Please find enclosed a revised version of our manuscript (MS) entitled, “The Pléiades Glacier Observatory: high resolution digital elevation models and ortho-imagery to monitor glacier change”. To facilitate your assessment, we uploaded a clean and track-change version of the revised MS.

Reply to David Shean

Fig 7 - NMAD for BM and SGM compared to lidar for Hellstugubreen

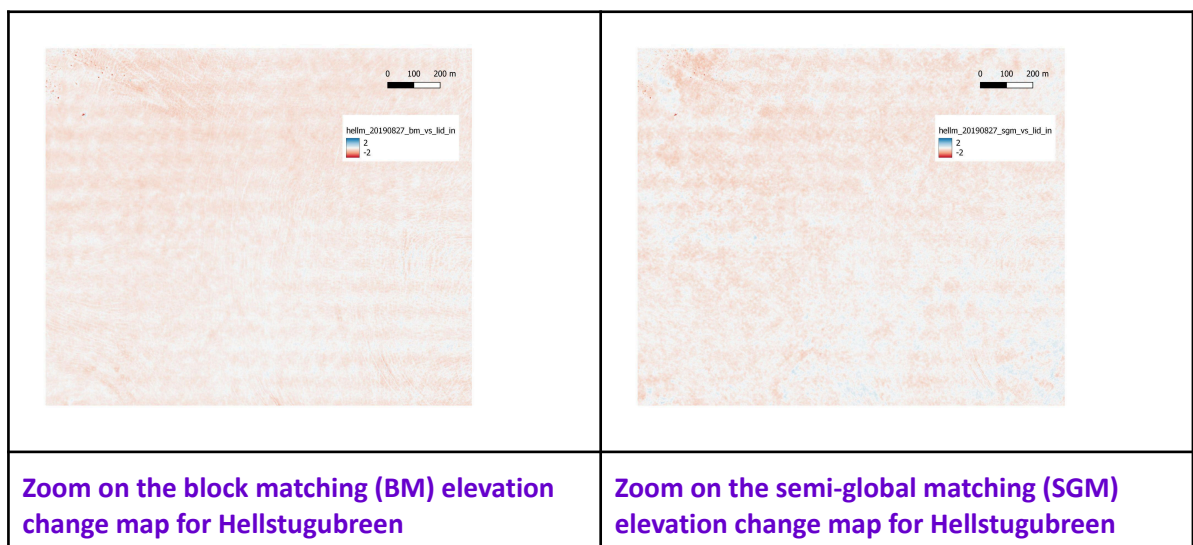
I think the authors misunderstood my earlier comment. It appears that there is larger residual horizontal geolocation error in the BM product compared to the SGM product, likely introduced during the independent co-registration process for each. Please check the translation vectors for the dh maps used to produce 7c and 7d - I can't do this because the products involving lidar data are not available (which is fine, but limits reproducibility).

I'm having a hard time understanding how the on-glacier NMAD values in Table 3 for the Hellstugubreen BM DEM (0.12 m, Fig 7c) is lower than the on-glacier NMAD for the Hellstugubreen SGM DEM (0.15 m, Fig 7d). Just looking at these difference maps (with identical color ramp), there appears to be more spread in the BM dh product than the SGM dh product (reproduced above for clarity). I'm wondering if there was potentially a mistake in the analysis/plotting code or labeling in the figure? Maybe double-check, and if necessary, modify the statement on linked 364-366:

We checked the NMADs (because we were also surprised by this result) and can confirm our numbers. This is the illustration that a color scale/representation can be misleading or, rather, not reflect the statistics. Below we zoom in on a very smooth area of Hellstugubreen, away from any crevasse field. These subsets illustrate very similar noise levels in the two correlation algorithms. As these smooth areas occupy most of the glacier, this likely explains why the NMAD are similar.
